ADDENDUM #2
ITB/RFP NUMBER: 2016045-FD-B
Harrisonburg Fire Station #1 Renovations ITB

City of Harrisonburg's Fire Station #1 Renovations ITB, is modified as follows:

DRAWING TITLE:
FLOOR PLAN CLARIFICATIONS

SUPPLEMENTAL DWG. NO:
AD2-A1

SECOND FLOOR PLAN

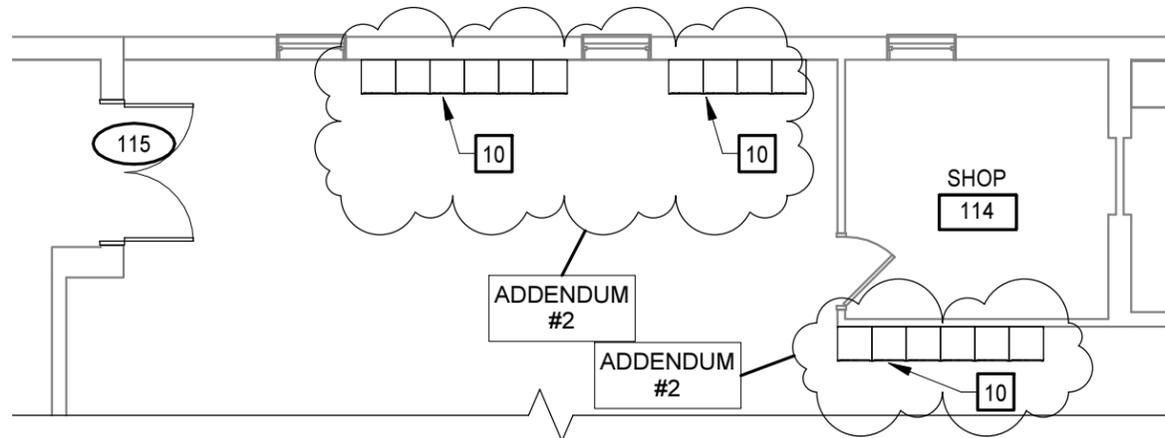
3. Question: The following question concerns Specification Section (number) 088300. Please provide elevation of the west wall in room 223 indicating location and quantity of mirrors.

11 SECOND FLOOR PLAN: In dimension string along west wall of Exercise Room, space 223,
12 **DELETE** 25'-0" MIRRORS THIS WALL" and **SUBSTITUTE** "(5) MIRRORS THIS WALL".

Answer: **Refer to Addendum No. 2, dated June 3, 2016.**

FIRST FLOOR PLAN

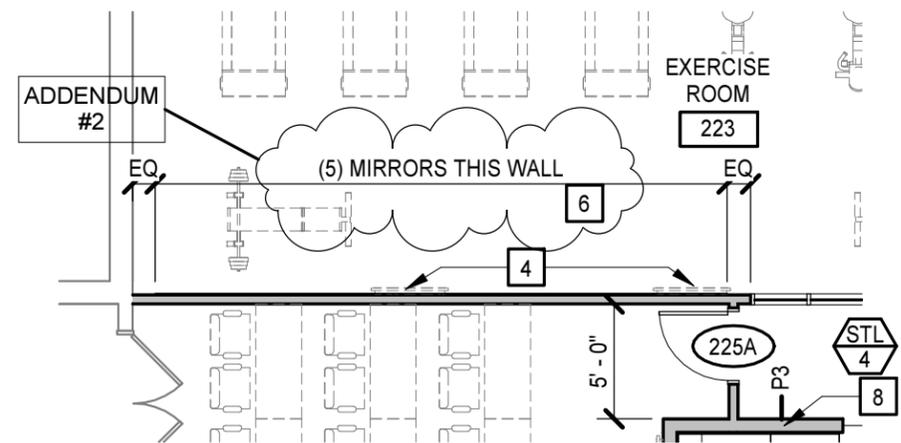
1. Question: The following question concerns Specifications Section (number) 105113.16. Please provide plans for the Metal Gear and Turnout Lockers.

13 FIRST FLOOR PLAN: **ADD** lockers and Keynote 10 TO South Apparatus Bays, space 111.

14 FLOOR PLAN KEYNOTES: At keynote 6, **DELETE** "5' FRAMELESS MIRRORS." and
15 **SUBSTITUTE** "5'-0" X 5'-0" FRAMELESS MIRRORS". **ADD** keynote 10, "(35) 18" x 18"
16 TURN OUT GEAR LOCKERS. COORDINATE EXACT LOCATION W/ OWNER.

Answer: **Refer to Addendum No. 2, dated June 3, 2016.**
